MATANUSKA-SUSITNA BOROUGH PLATTING BOARD AGENDA

**MARCH 18, 2021
REGULAR MEETING
1:00 P.M.**

- Platting Board Chair to read the Ex-Parte & Interest Memo.
 - A. **THORNOCK FAMILY INVESTMENTS LLC:** The request is to create nine lots, from Tract E-1, Memory Hills, Plat No. 2020-033, to be known as **MEMORY HILLS 2**, containing 44.79 acres +/- . The plat is located north of N. Bull Moose Drive, east of N. Galloway Drive and is bisected by E. Ridgeview Drive, (Tax ID # 57997000T00E-1); within the SW ¼ Section 23, Township 18 North, Range 01 West, Seward Meridian, Alaska. In Tanaina Community Council and Assembly District #6 Jesse Sumner

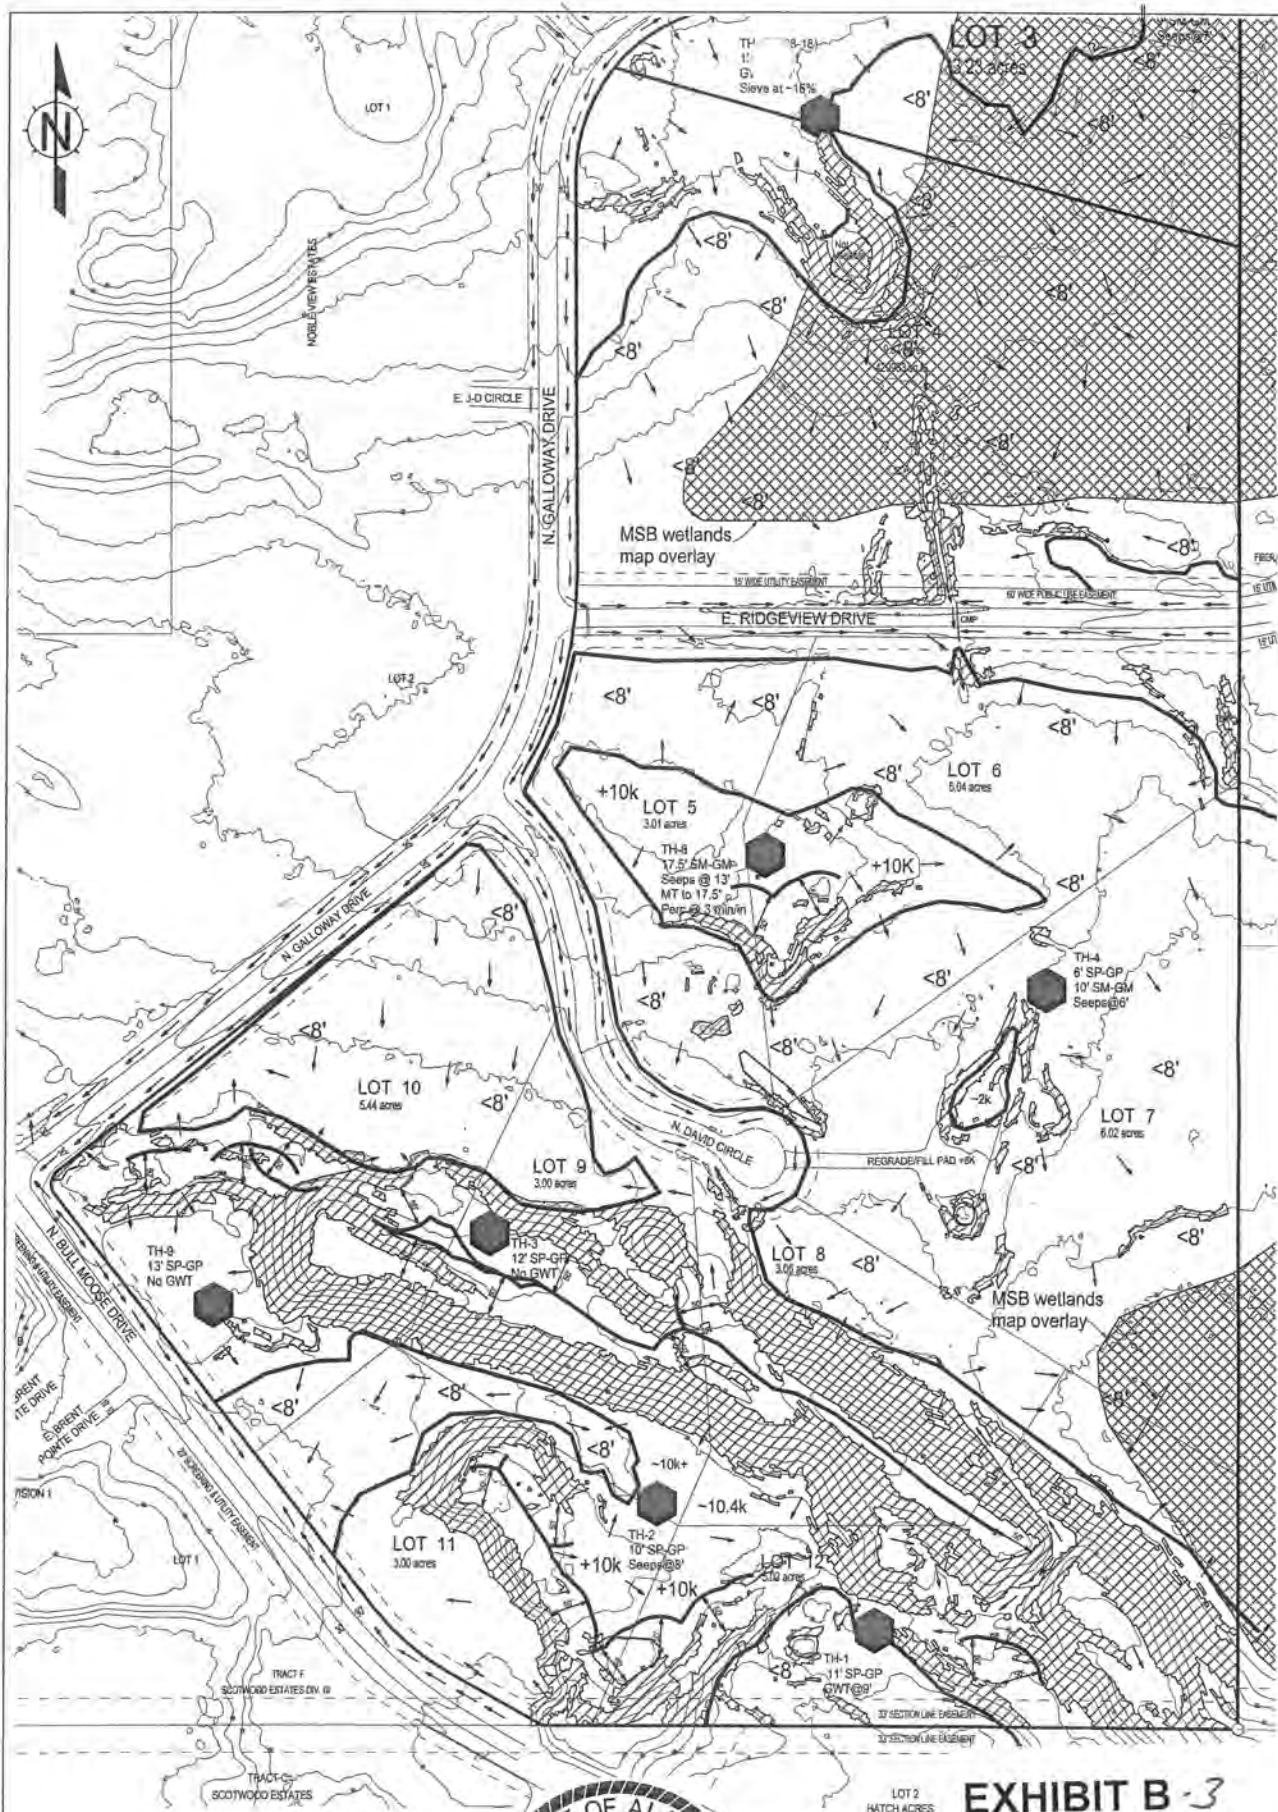
Groundwater. Groundwater was encountered on the project in four of the test holes. Groundwater in the form of seepage was encountered below the original grade in testholes 1, 4, 2, and 8, at levels of 9', 6', 8' and 13' respectively. The remaining testholes found no evidence of groundwater. Groundwater will be a limiting factor for some of the proposed lots; the estimated limit of area with over 8' to groundwater is delineated on the attached drawing.

Roads & Traffic Analysis. See the attached map. The project should not require construction of any new road, as each lot is served by existing roads. Based on the projected lot count and present standards, no road upgrades will be needed; a traffic/lot count map is attached. Each new lot will have a reasonable access point onto an existing street, and private drives can be constructed with reasonable grades.

Drainage Plan. As all access roads presently exist, no road construction is planned and no drainage plan is required. The attached map shows the approximate existing drainage patterns and drainage structures along the existing roads. See the attached map for details.

PROPOSED REPLACEMENT P.U.E.AND ASBUILT

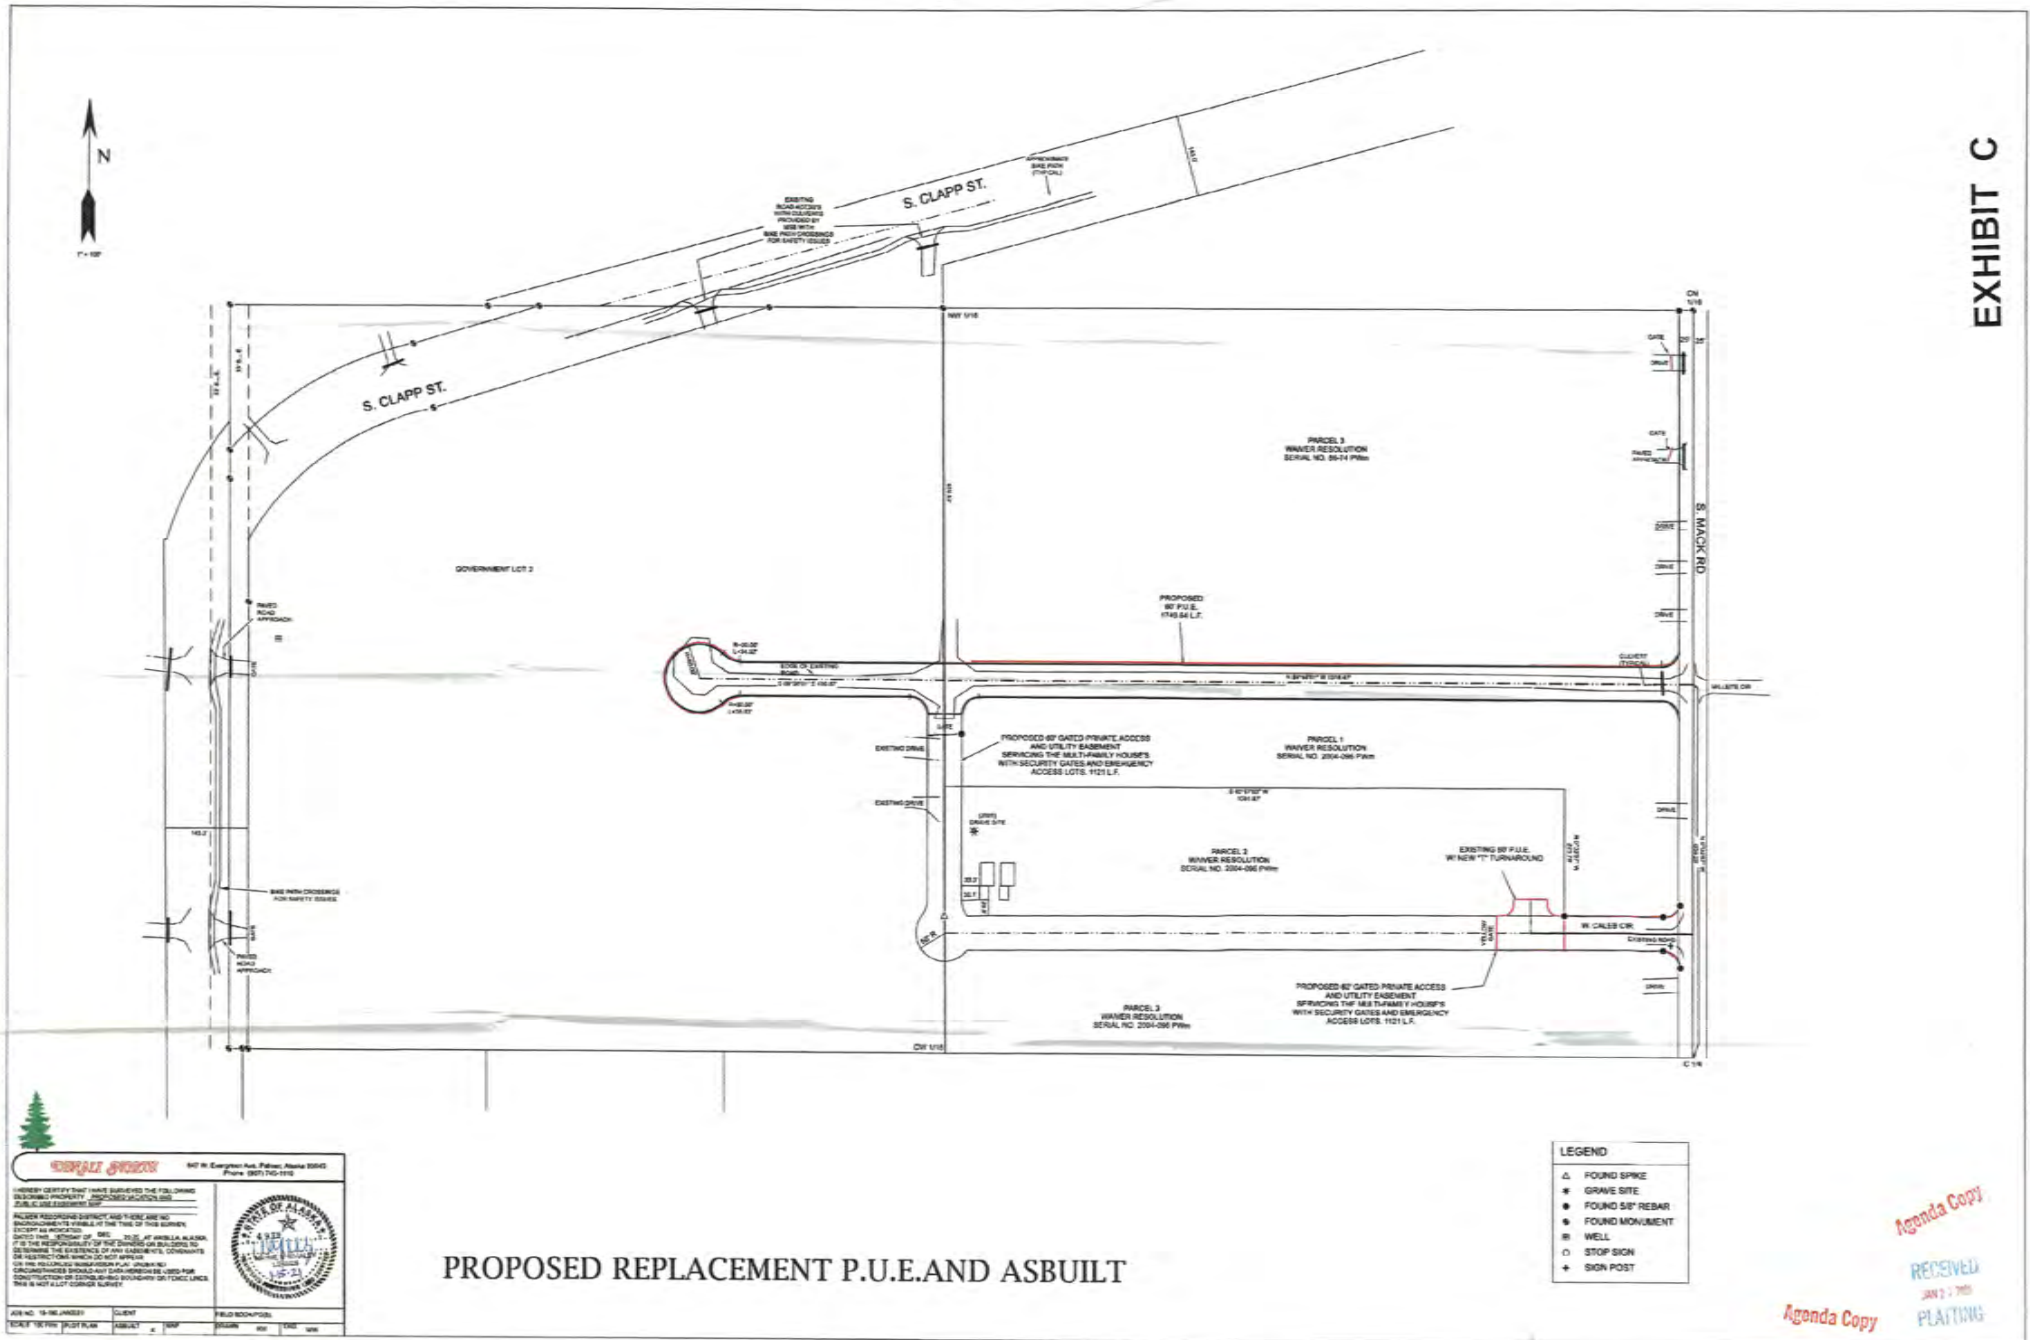
The Surveyor's January 15, 2021 letter says there is a portion of the Mill Site Circle PUE that is steeper than 10%. 2011 contours (the only ones available?) of the alignment show grades closer to 20%. Per 43.15.021 (C), plan, profile, and cross sections are required if existing grades along the proposed route exceed 10%. The description for said easement refers to an Attachment "A", but I don't see it in the packet.
